February 6, 2009

**ADDENDUM NO. 2**  
**OFFICE OF CULTURAL AFFAIRS TENANT IMPROVEMENTS PROJECT**

Notice is hereby given that the following revisions, additions and/or deletions are hereby made of, and incorporated into plans and specifications for the **OFFICE OF CULTURAL AFFAIRS TENANT IMPROVEMENTS PROJECT**.

SK-1

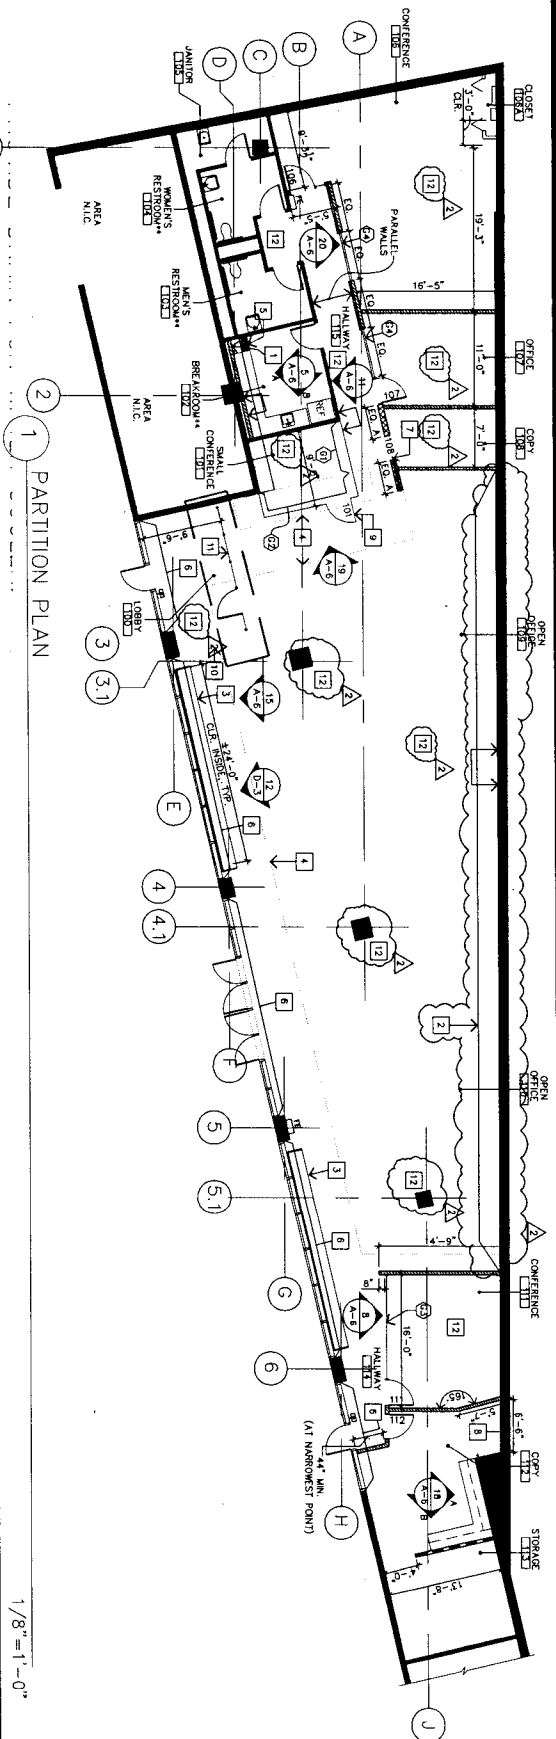
The demo plan calls for the removal of the electric closet walls and door. The partition plan indicates this as existing.

Existing doors and frames are to be left on-site for pickup by the Convention Center personnel. No other material is to be salvaged.

**Revised demolition key note #11 on sheet A-1. See attached SK-1.**

**See demolition key note #12 on sheet A-1. See attached SK-1.**

- 11 (E) WALL & DOOR TO ELEC. CLOSET TO REMAIN.
- 12 DOORS THAT ARE SHOWN TO BE REMOVED SHALL BE LEFT AT SITE TO BE PICKED UP BY CONVENTION CENTER PERSONNEL. COORDINATE WITH CONVENTION CENTER PERSONNEL.
- 13 SALVAGE ANY LINEAR FLUORESCENT LIGHT FIXTURE THAT CAN BE REUSED AND IS MORE ECONOMICAL THAN PROVIDING NEW FIXTURE AT STORAGE ROOM # 113.

A-2

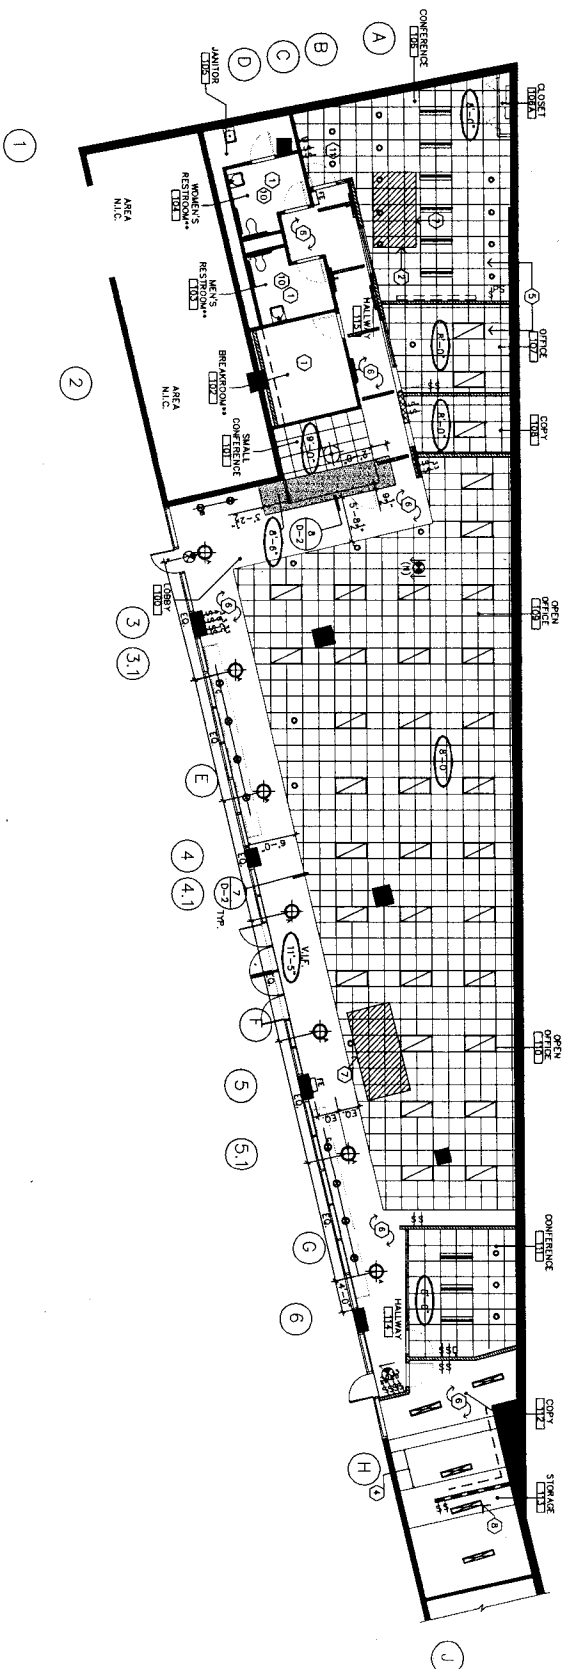
1. **Revise** Partition Plan, Partition Key Notes, Partition Legends of Sheet A-2.
  - **See attached SK-2 which shows portion of revise sheet A-2.**
2. **Clarification** on sheet A-5.

Sheet A-2- Should the furring at the back wall run continuous?

Sheet A.2- Please clarify Note 7.

Sheet A-2, Note 6, calls for 3'-0" VIF but Sheet A-5, WC-2, calls for 3'-6" VIF. Which note should be included in the bid?

Existing drywall walls which are to remain will receive a skim coat to bring them to a level 4 finish.

Pocket Door shown inside wall on sheet A-2. Detail 13/D-1 does not show complete wall dimensions for Barn Door.

**Revised partition key note #2 on sheet A-2. See attached SK-2.**

**Revised partition key note #7. See attached SK-2.**

**Revised partition key note #6. See attached SK-2.**

**See sheet A-2, note #12. See attached SK-2.**

2 NEW DRYWALL FURRING ALONG BACK WALL TO MATCH EXISTING, SEE DETAIL 13/D-2  
CONTRACTOR TO VERIFY IF EXISTING FURRING IS ADEQUATE FOR ELECTRICAL WIRING CONNECTIONS, IF IT IS NOT ADEQUATE REMOVE EXISTING FURRING AND PROVIDE NEW AS INDICATED.

6 PROVIDE TRANSLUCENT FILM AT INTERIOR SIDE OF EXTERIOR GLAZING FROM FLOOR TO MILLWORK HEIGHT, ± 3'-6" V.I.F.

7 CONTRACTOR TO ENSURE THAT POCKET DOOR WILL GO FULLY INSIDE THE POCKET. INFORM THE ARCHITECT IF INDICATED DIMENSION HAS CONFLICT.  
INTENT IS THAT THE POCKET SIZE SHALL BE SUCH THAT WHEN DOOR IS FULLY OPEN REQUIRED MINIMUM CLEARANCE OF 32" CLEAR OF ANY HARDWARE IS ACHIEVED.

12 EXISTING WALLS TO RECEIVE SKIM COAT FOR LEVEL 4 FINISH.

SK-3

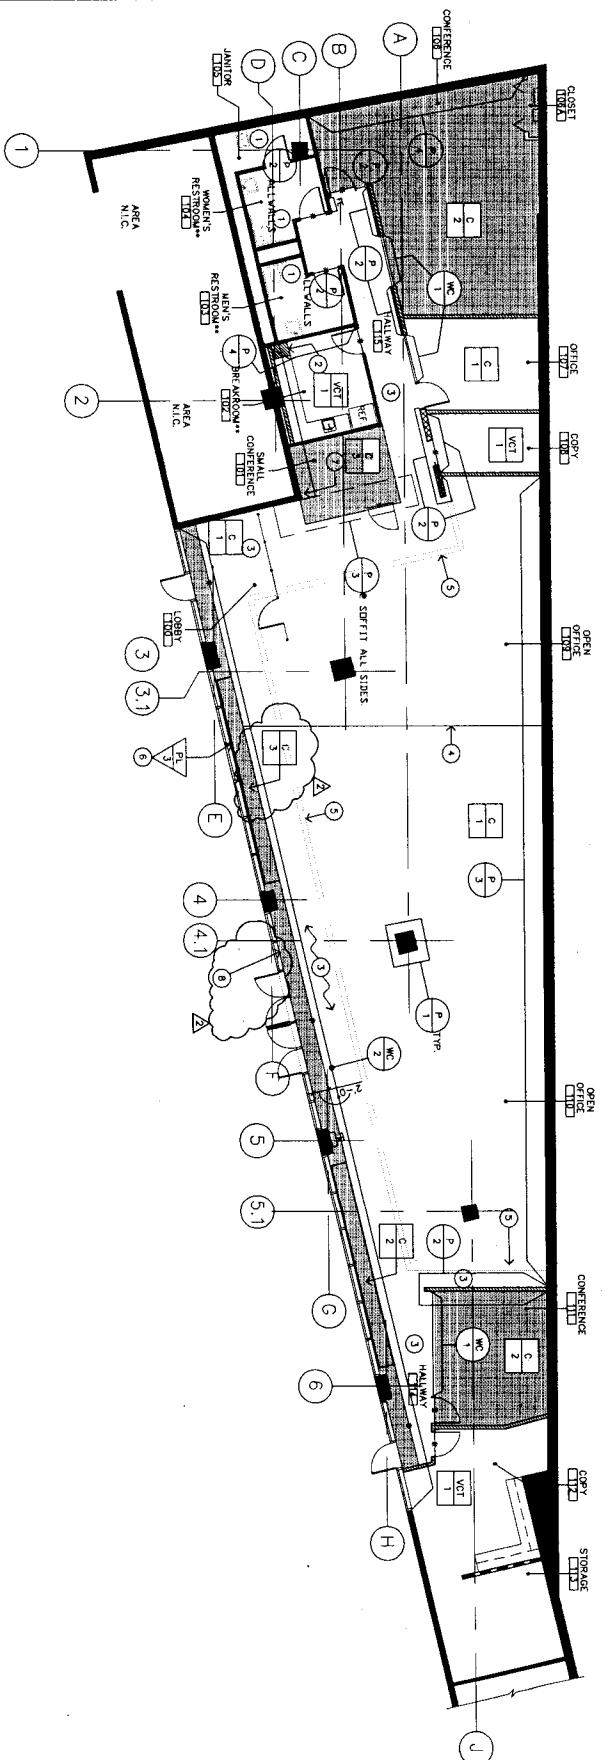
Sheet A-3, Conference Room 101 ceiling does not match any of the legends. Please clarify.

On RCP sheet A-3 specs for ceiling items 1&3 where do they occur?

The fixture schedule notes for FIXTURE TYPE H that the contractor is to confirm the FIXTURE LENGTH with the architect.

**Revised legend. See attached SK-3.**

**Fixture type is indicated under RCP legend. Length is 4'-0". See attached SK-3.**

NEW ARMSTRONG :  
TILE : ARMSTRONG ULTIMA TEGULAR, # 1912, NRC 0.70, 2X2.  
GRID: ARMSTRONG, SUPRAFINE XL, 9/16", 2X2.

NEW SURFACE MOUNTED FLUORESCENT LIGHT FIXTURE, LIGHTOLIER JET STAR  
FLUORESCENT JS4A232120SO 4'-0" LONG

SK-4

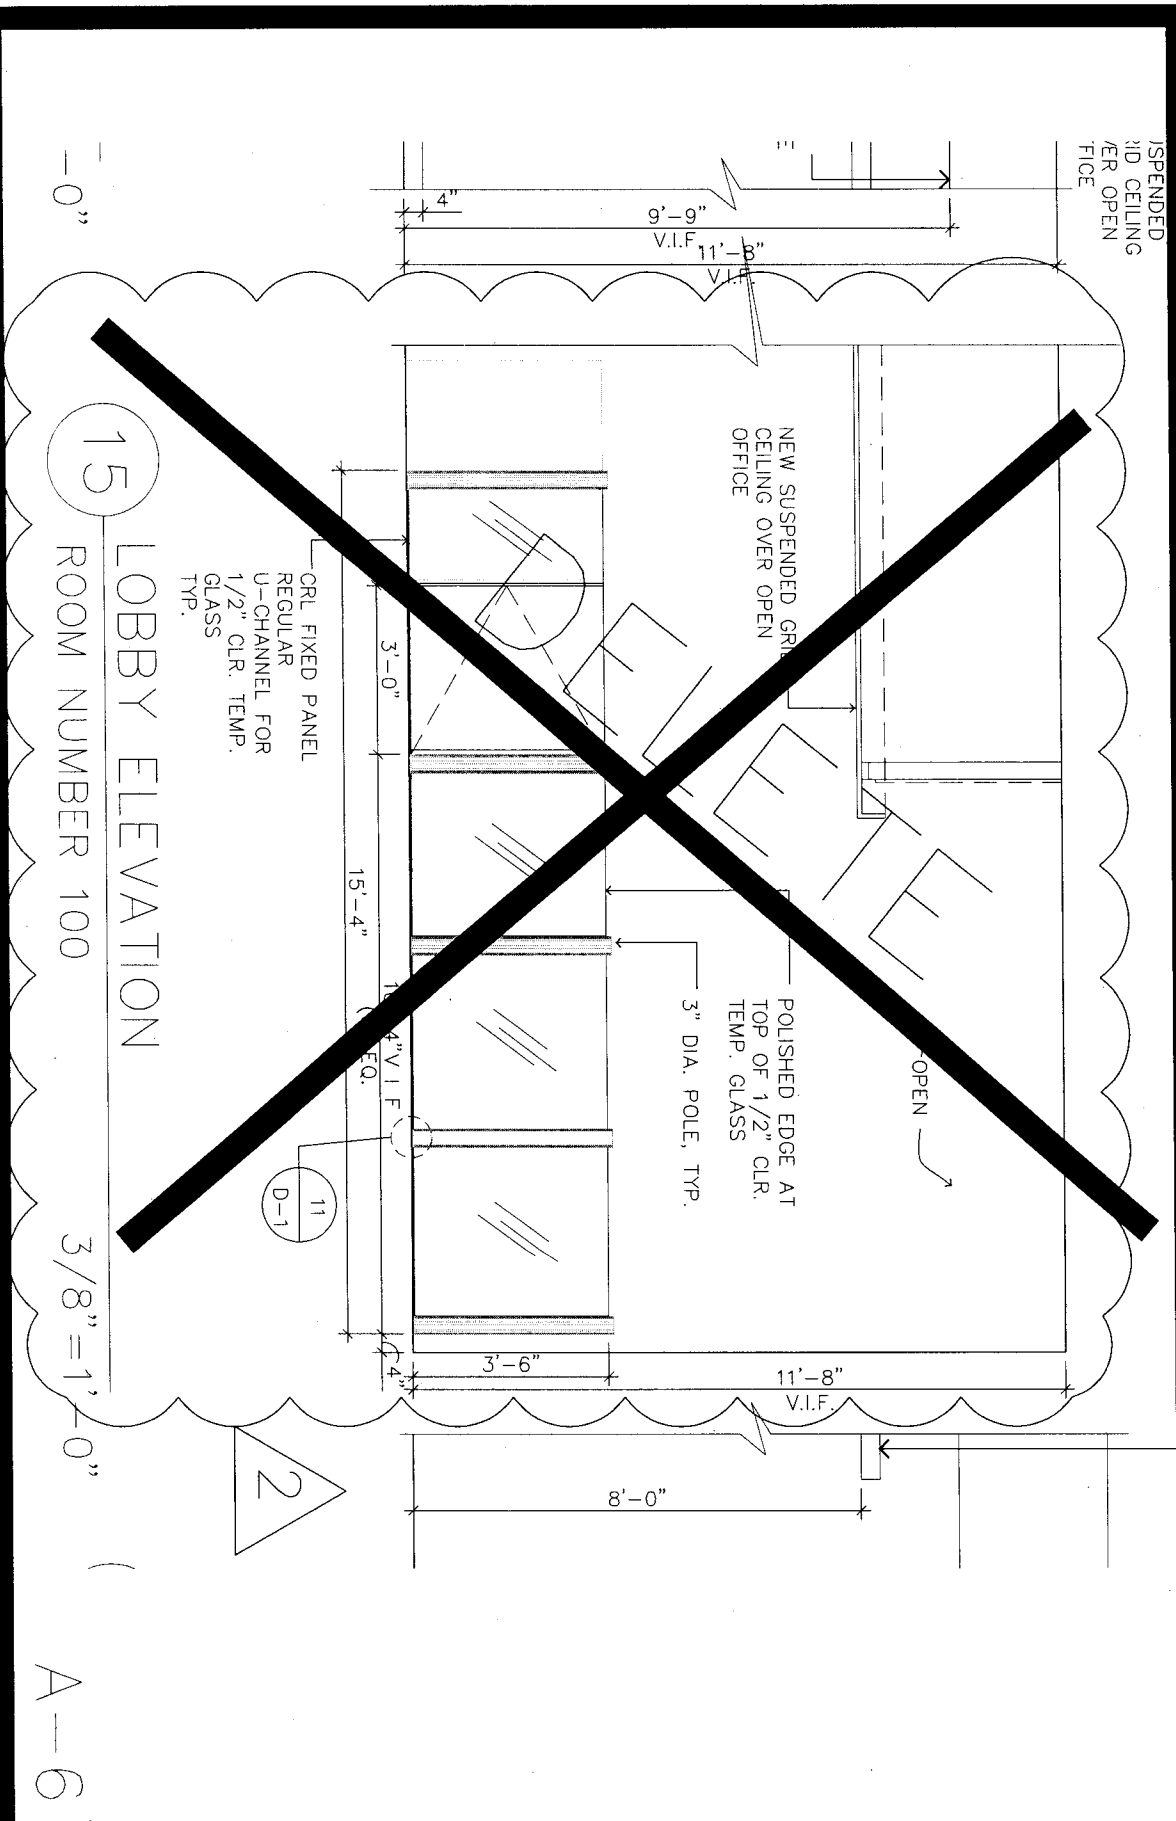
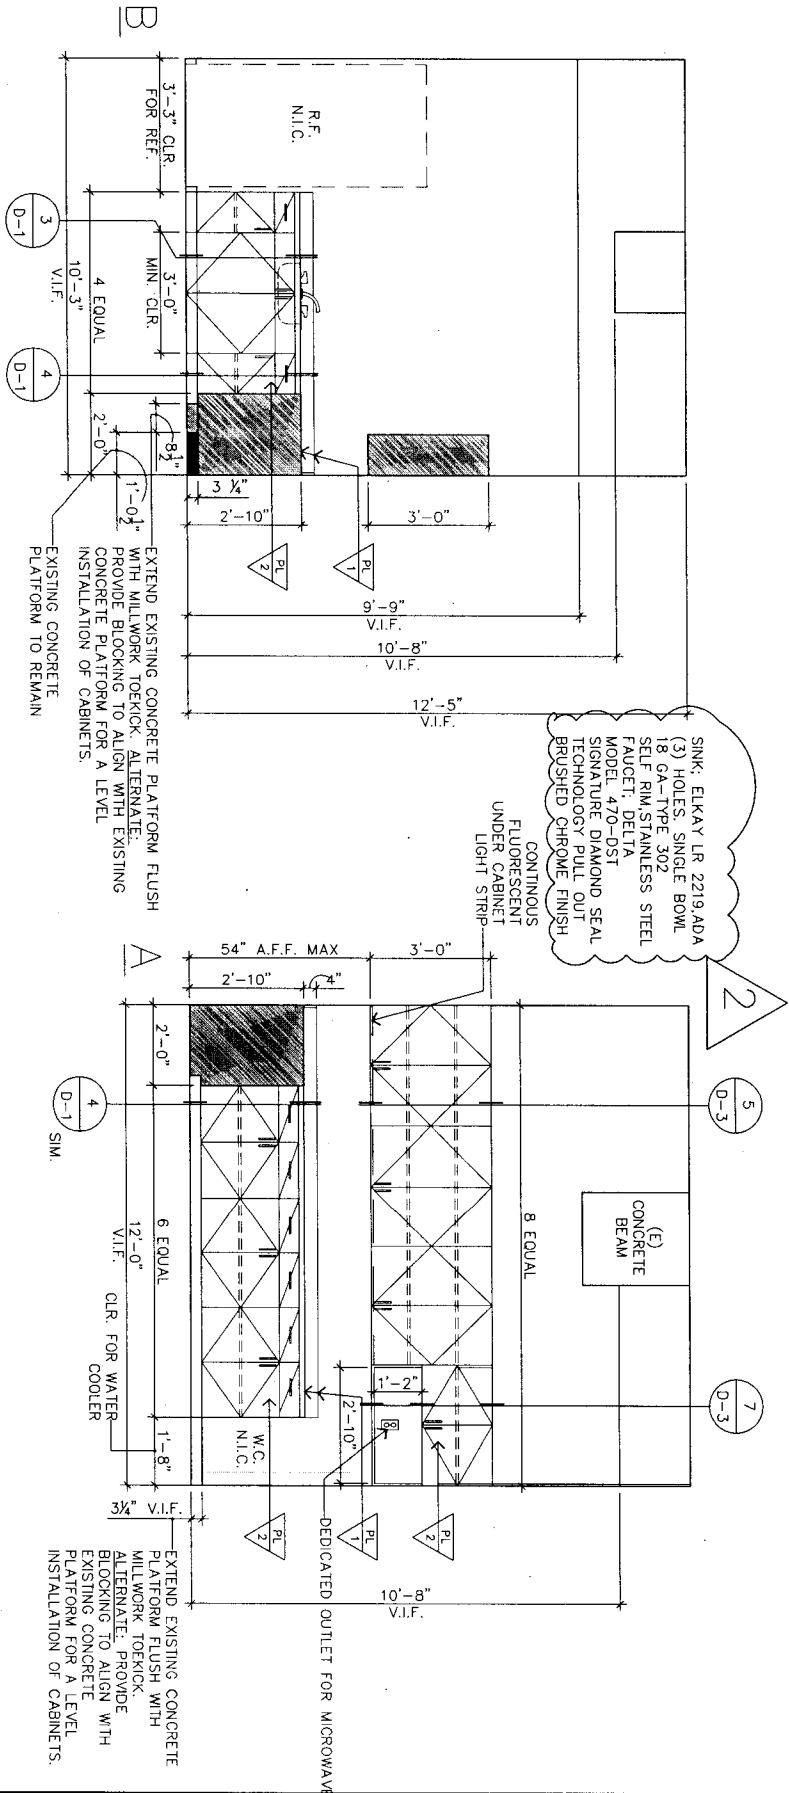
- **Carpet C-3 to be broadloom at conference room 101 and tile at front parallel to exterior window wall.**
  - **Revise Carpet strip at front near exterior glazing to carpet tile C-3.**

**See attached SK-4 which shows portion of revise sheet A-5.**
3. **Clarification** on sheet A-6.
  - **Delete elevation 15/A-6.**  
**See attached SK-5 which shows portion of revise sheet A-6.**

PROVIDE BROADLOOM AT ROOM 101.  
PROVIDE CARPET TILE AT STRIP AT FRONT  
PARALLEL TO EXTERIOR GLAZING.

SK-7

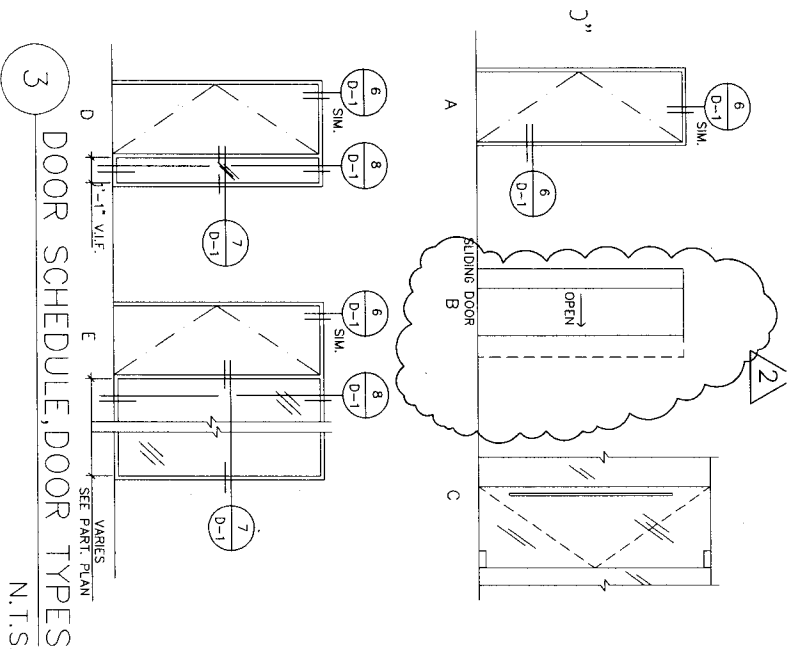
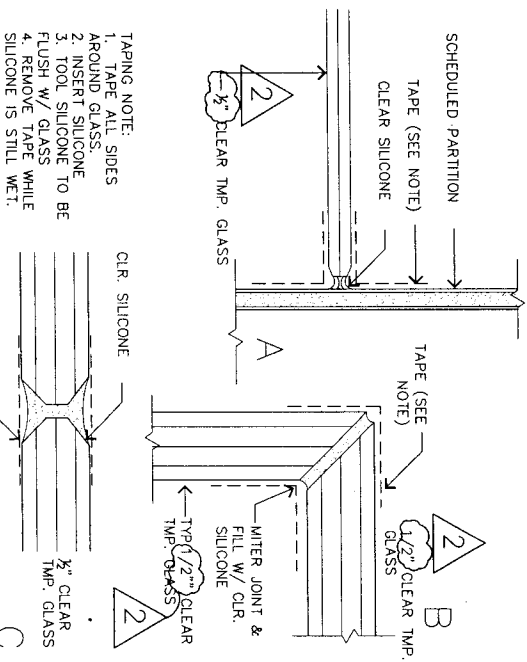
- **Revise hager latchset to Schlage 'L' SERIES latchset. See attached SK-7.**
  - **Revise hardware group 3HW-4 for pocket / sliding door. See attached SK-7.**

Which type of locksets to be used? Hagar or Schlage?

Unable to locate Latchset Hagar series 5100.

What color is specified for Door and Glass Sidelights Aluminum Frames?

**Schlage 'L' series or approved equal. See attached SK-7.**

**Use Schlage 'L' series or approved equal. See attached SK-7.**

**Clear anodized Aluminum. See attached SK-7.**

HARDWARE SPECIFICATIONS:  
 HINGES: HAGER, FULL MORTISE, BB 1279  
 LOCKSETS: SCHLAGE, "L" SERIES, TUBULAR  
 FINISH: CHROMIUM DULL, US 260  
 DOOR STOP: VES, FS 13 DOME STOP  
 SEAL: PEMKO S880

SK-8

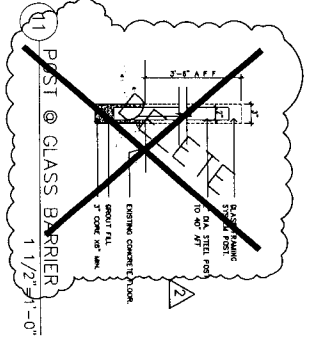
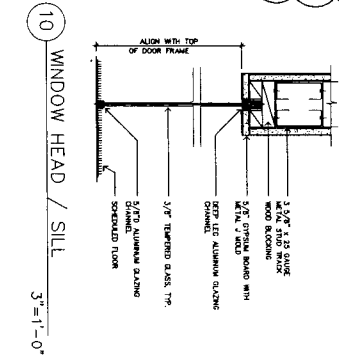
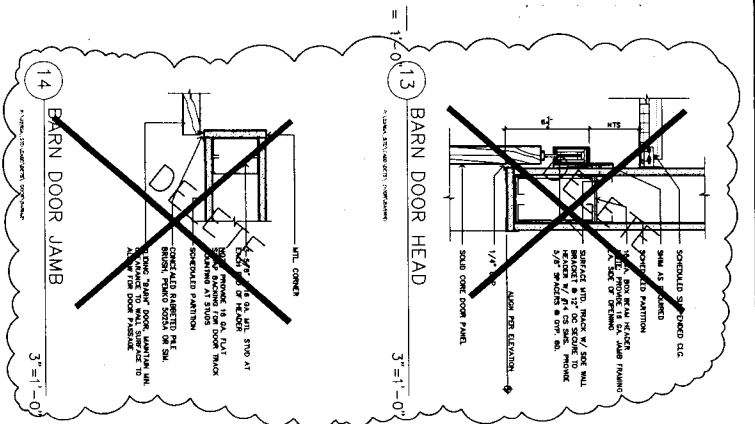
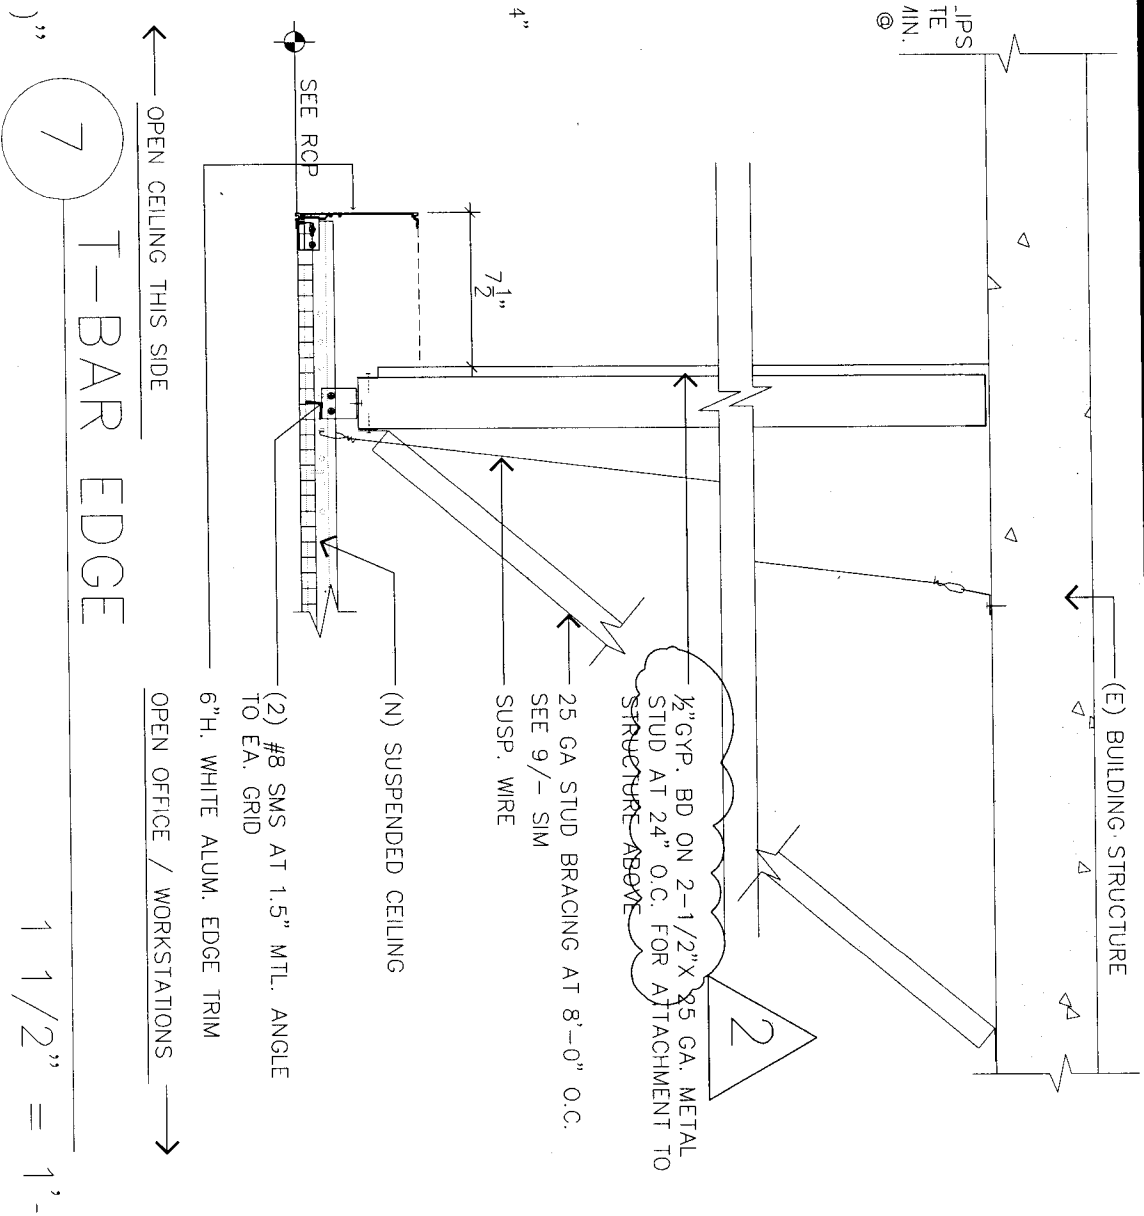
4. **Revision** which shows portion of revise sheet D-2.
  - **Delete details 11, 13 & 14 /D-1. See attached SK-8.**
  - **Revise detail 16/ D-1 for ½' THICK GLASS. See attached SK-8.**

16 GLAZING DETAIL  
BUTT JOINT N.T.S.

SK-9

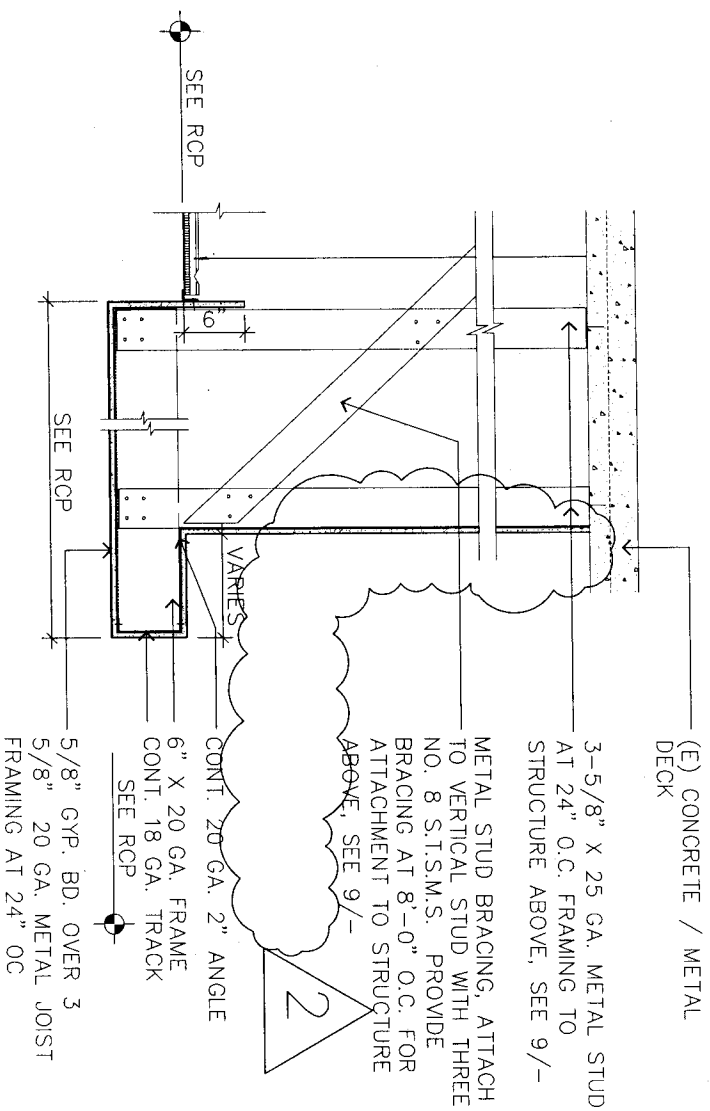
- **Revise** detail 7/D-2. Metal stud to structure above to be 2-1/2" with 1/2 " gyp. Board. **See attached SK-9.**  
**Revise** detail 8/D-2. **See attached SK-10.**

Can you please ask the architect if it would be ok to change the soffit detail on page D-2 #7 from 3 5/8" 25ga. studs with 5/8" sheetrock to 2 1/2" 25ga. studs with 1/2" sheetrock?

This will lighten the soffit which is to hang from the concrete for T-bar ceiling tie in. Approx. 130lf. of soffit is shown on the drawings.

**See attached SK-9 for revised detail 7/D-2.**
